Product Information Notice

Models: GB142-24,30,45,60

Brand: Buderus

Subject: GB142 Vent Adaptor Inspection

Figure 1

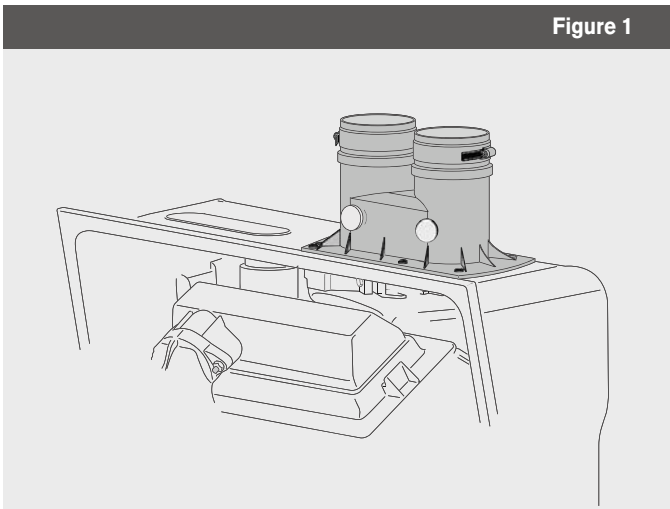
The aluminum vent adaptor has been modified and is now made of polypropylene to eliminate corrosion of the vent adaptor (see Fig. 1).

The polypropylene adaptor (p/n 8718600686) has an internal condensate drain which eliminates the need for an external condensate tee previously required with the aluminum vent adaptor.
